SUBJECT: Contract 008066
SR 520, Floating Bridge and Landings Project
Federal Aid No. BR-0520(047)
Change Order No. 122 – PPDB Revisions

**WASHINGTON STATE
DEPARTMENT OF TRANSPORTATION
CHANGE ORDER**

CONTRACT NO: 008066 FEDERAL AID NO: BR-0520(047)
CONTRACT TITLE: SR 520 / I-5 TO MEDINA - EVERGREEN POINT FLOATING
CHANGE ORDER NO: 122 R1 PPDB REVISIONS

APPENDIX M22
 PONTOON
 MINIMUM TECHNICAL REQUIREMENTS
 KEEL SLAB PLAN

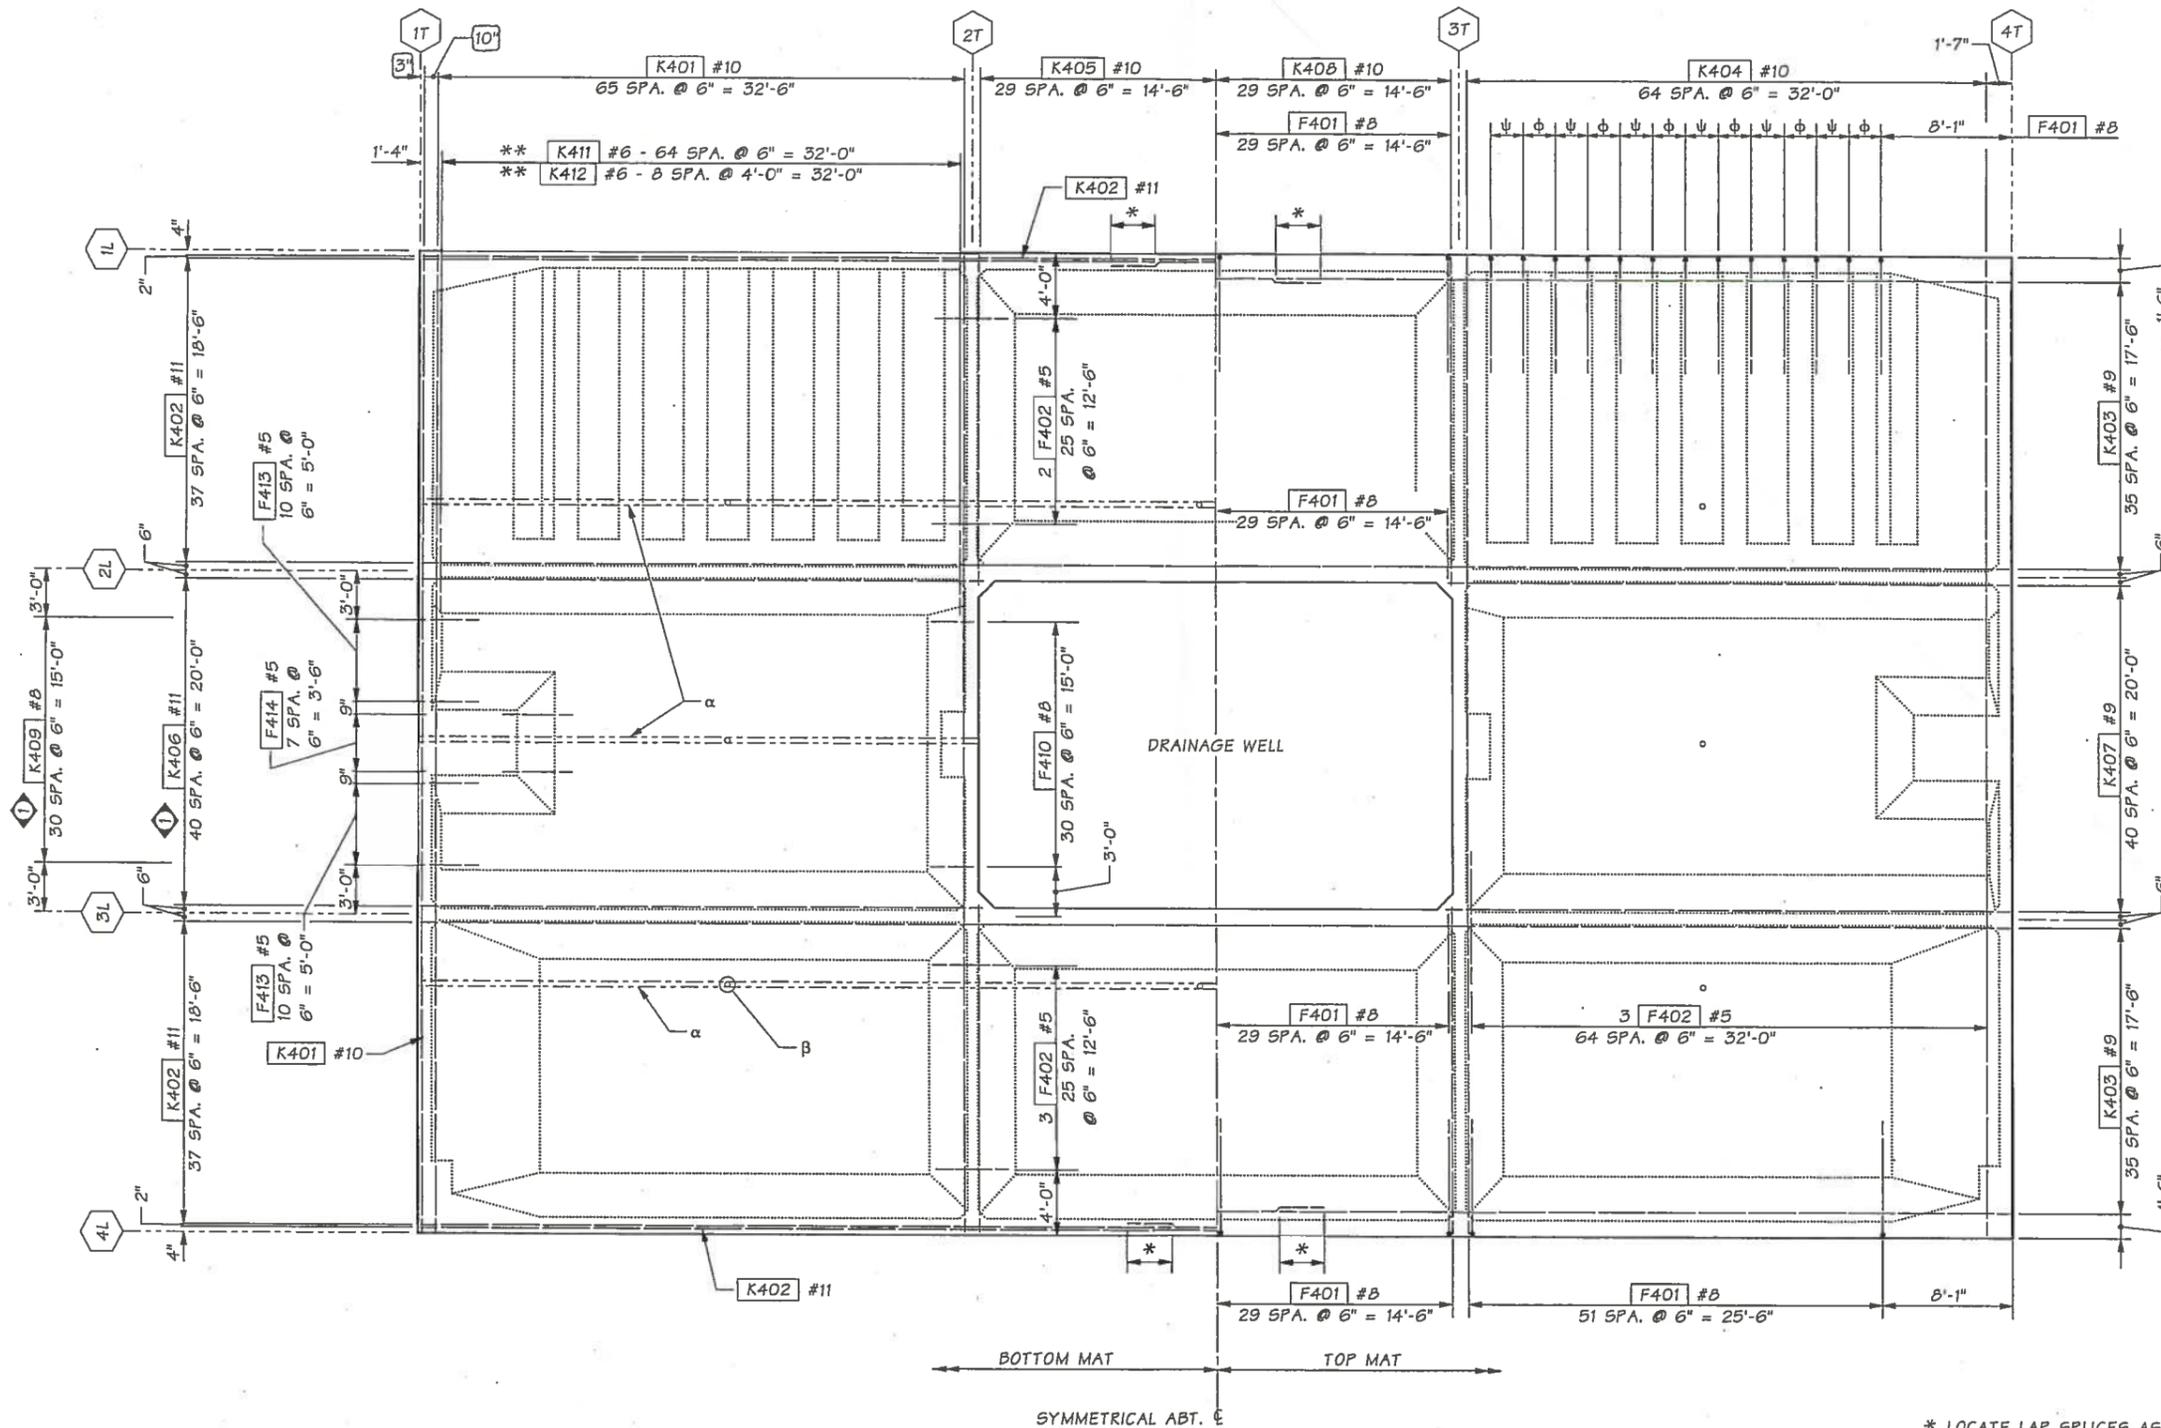
The following Pontoon Technical Minimum Requirements (Appendix M22) plan sheets shall be deleted and replaced with the plan sheets provided on pages 6 through 15 of this change order. The replacement plan sheets are for the Type 2 Supplemental Stability pontoons Bridge Sheets No. SS2, SS7, SS19, SS20, and SS25; and Type 5 Supplement Stability pontoons Bridge Sheets No. S2, S7, S19, S20 and S25.

APPENDIX M22 PANTOON MINIMUM TECHNICAL REQUIREMENTS
 DETAILS 3

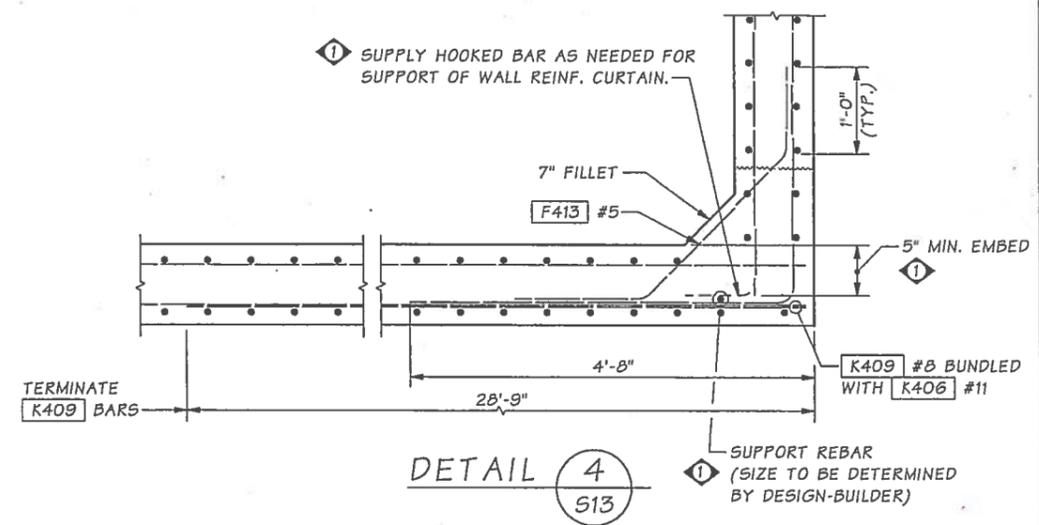
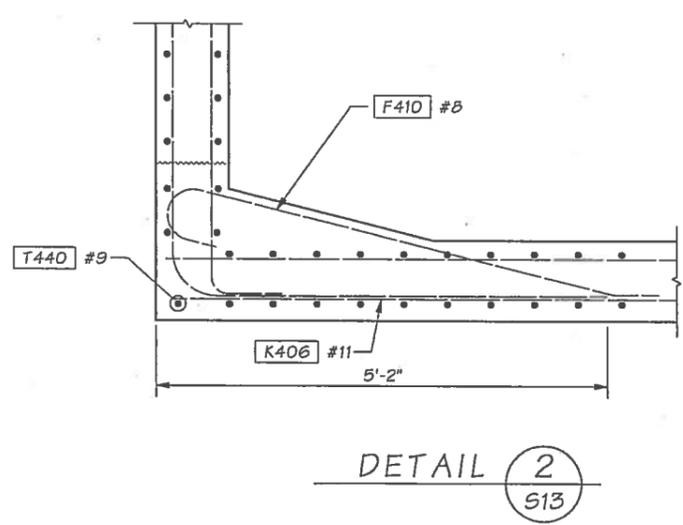
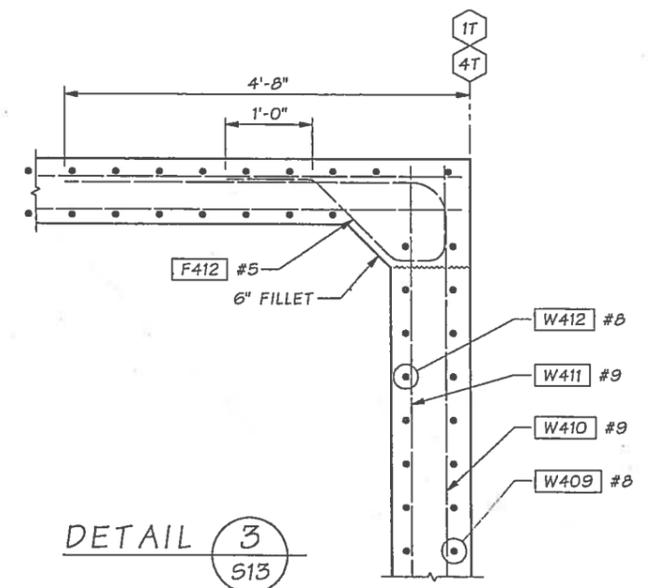
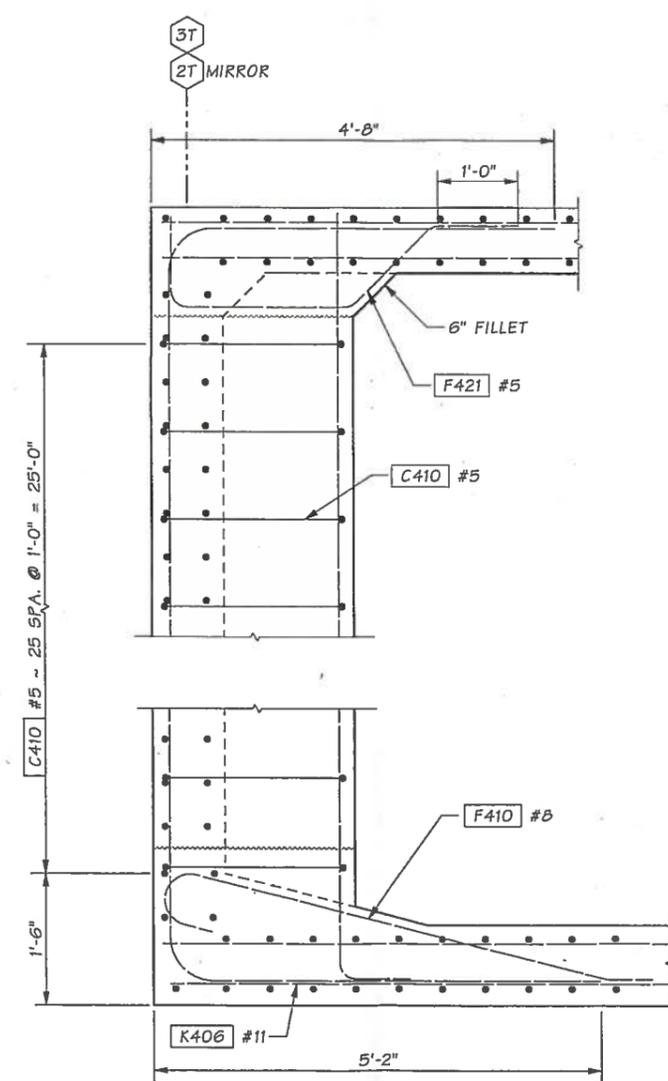
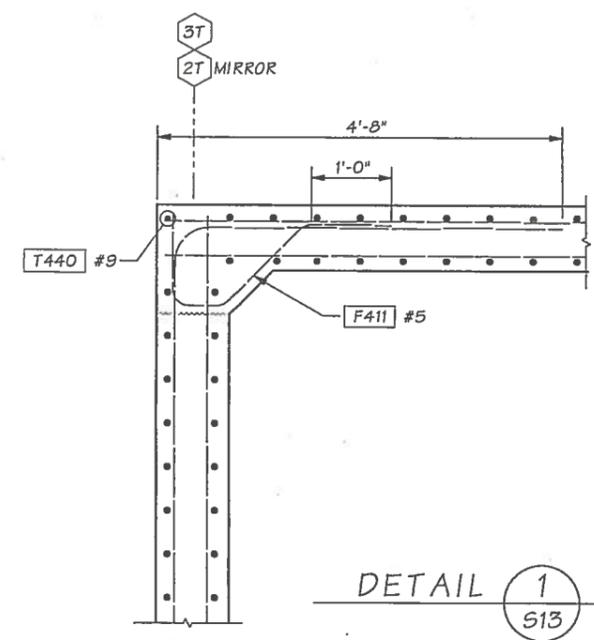
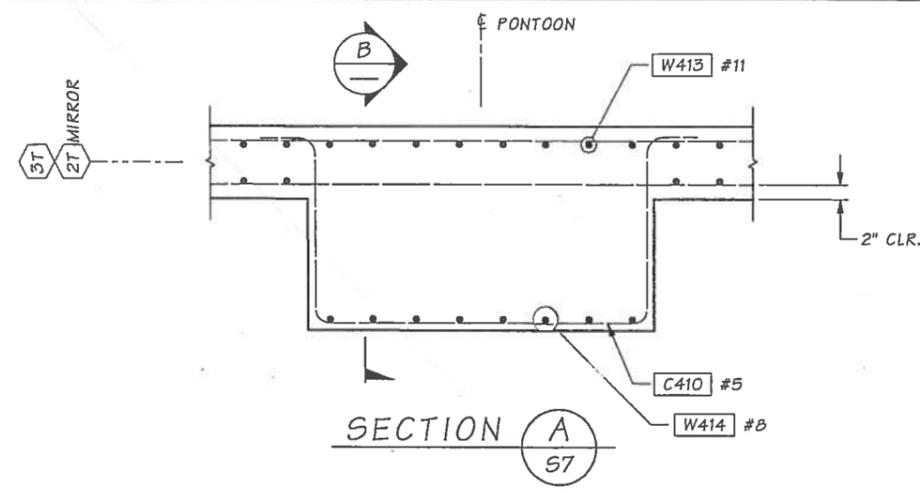
Bridge Design Engr.	Khaileghi, B	M:\W-Team\SR 520 FLOATING BRIDGE\M22 PMTR>window files\519-DET 3.wnd	
Supervisor	Clarke, PT	REGION NO.	STATE
Designed By	Spitznas, P	10	WASH.
Checked By	Ferluga, E	JOB NUMBER 10A057	
Detailed By	Gunis, E	DATE	
Bridge Projects Engr.	11/2012	REV. BAR TO RELIEVE CONGESTION	EJF
Prelim. Plan By	03/2011	AD15 - REVISED SECTIONS & DETAILS	ADK
Architect/Specialist	DATE	REVISION	BY APPD

APPENDIX M22
 PONTOON
 MINIMUM TECHNICAL REQUIREMENTS
 DETAILS 4

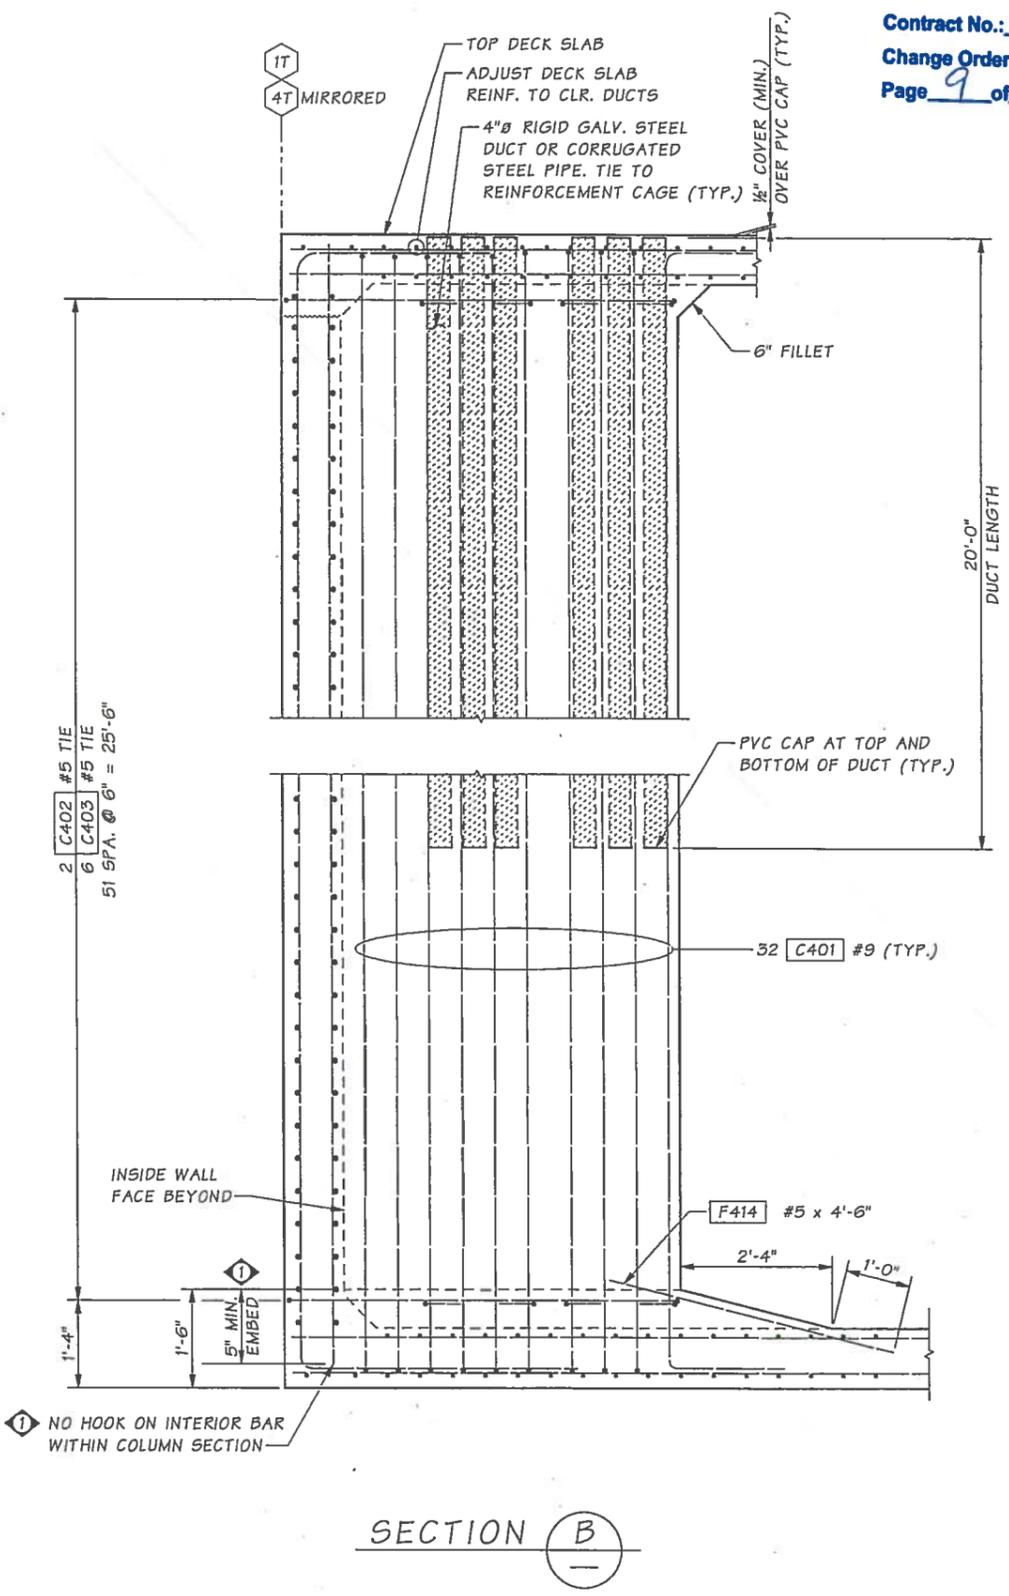
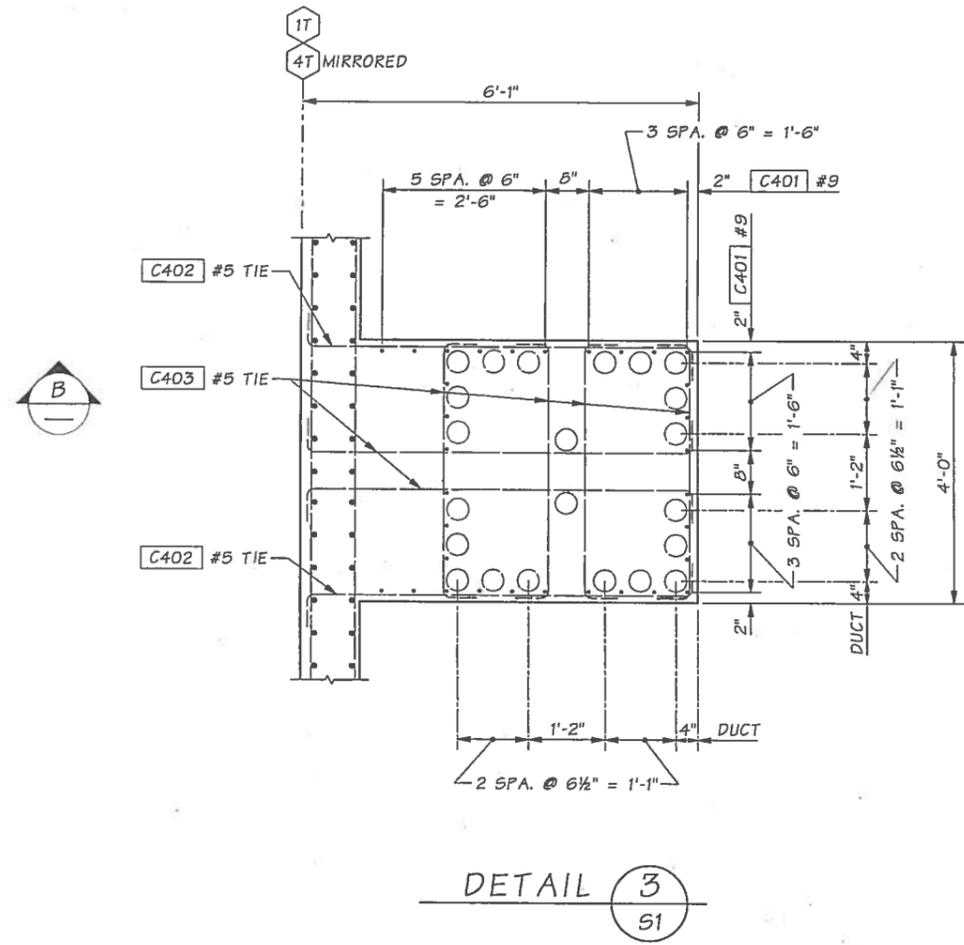
Bridge Design Engr.	Khaleghi, B	M:\W-Team\SR 520 FLOATING BRIDGE\M22 PMTR>window files\S20-DET 4.wnd			
Supervisor	Clarke, PT	REGION NO.	STATE	FED. AID PROJ. NO.	SHEET NO.
Designed By	Spitznas, P	10	WASH.		TOTAL SHEETS
Checked By	Ferluga, E				
Detailed By	Gunis, E				
Bridge Projects Engr.		DATE	REVISION	BY	APPD
Prelim. Plan By		11/2012	REV. BAR TO RELIEVE CONGESTION	EJF	
Architect/Specialist		03/2011	AD15 - REVISED SEC. 5 & BAR NUMBERS	ADH
